HATTIE QUINNIE SUBDIVISION

APPLICATION NUMBER 13 DATE September 1, 2011

REQUEST Subdivision

DETAIL SITE PLAN

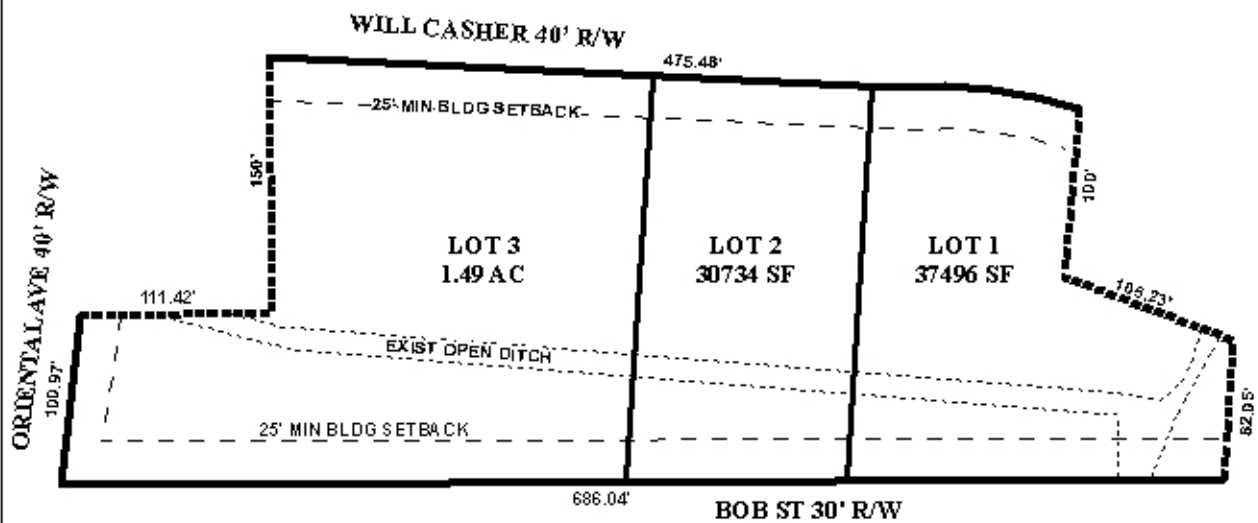
The purpose of this application is to subdivide two existing metes-and-bounds parcels into three legal lots of record. All lots would meet the minimum requirements of the Subdivision Regulations. The plat should be revised to label each lot with its size in acres and square feet after any required street dedication, or a table should be furnished on the Final Plat providing the same information. Lots 1 and 3 do not meet the standards of Section V.D.1. due to their unusual shapes; however, due to the shape of the over-all site, a waiver of Section V.D.1. would be in order.

The site is fronted by Will Casher Lane on the North with a 40' right-of-way; Smith Street on the West with a 40' right-of-way; and Bob Street on the South with a 30' right-of-way, all of which are of substandard width and without curb and gutter, and Bob Street is unpaved. Therefore, dedication should be required to provide 30' from the centerline of all three streets. Also, dedication should be required to provide a corner radius of 25' at the intersection of Smith Street and Bob Street. The plat should be revised to indicate the 25' minimum building setback line along all street frontages as measured from any required dedication. And since Bob Street is a

dead-end street and would normally require a 120' minimum diameter turn-around, the 25' minimum building setback for Lot 1 along Bob Street should be revised to be measured from a possible future 120' diameter turn-around right-of-way.

As a means of access management, a note should be required on the Final Plat stating that Lots 1 and 2 are each limited to one curb cut to Will Casher Lane, and Lot 3 is limited to one curb cut to Will Casher Lane and one curb cut to Smith Street, with the size, location, and design to be approved by Traffic Engineering and conform to AASHTO standards. A note should also be required on the Final Plat stating that all lots are denied direct access to Bob Street until such time that it is developed to City standards after which Lots 1 and 3 are allowed two curb cuts each to Bob Street, and Lot 2 is allowed one curb cut to Bob Street, with the size, location and design of all curb cuts to be approved by Traffic Engineering and conform to AASHTO standards.

- 1) revision of the plat to label each lot with its size in square feet and acres after any required street dedication, or the furnishing of a table on the Final Plat providing the same information;

- 2) dedication to provide 30' from the centerline of Will Casher Lane, Smith Street, and Bob Street;
- 3) dedication to provide a 25' corner radius at the intersection of Smith Street and Bob Street;

- 4) revision of the plat to illustrate the 25' minimum building setback line along all street frontages as measured from any required dedication;
- 5) revision of the plat to illustrate the 25' minimum building setback line for Lot 1 along Bob Street as measured from any future 120' diameter turn-around right-of-way;

- 6) placement of a note on the Final Plat stating that Lots 1 and 2 are each limited to one curb cut to Will Casher Lane, and Lot 3 is limited to one curb cut to Will Casher Lane and one curb cut to Smith Street, with the size, location, and design to be approved by Traffic Engineering and conform to AASHTO standards;

- 7) placement of a note on the Final Plat stating that all lots are denied direct access to Bob Street until such time that it is developed to City standards, after which Lots 1 and 3 are allowed two curb cuts each to Bob Street, and Lot 2 is allowed one curb cut to Bob Street, with the size, location and design of all curb cuts to be approved by Traffic Engineering and conform to AASHTO standards;
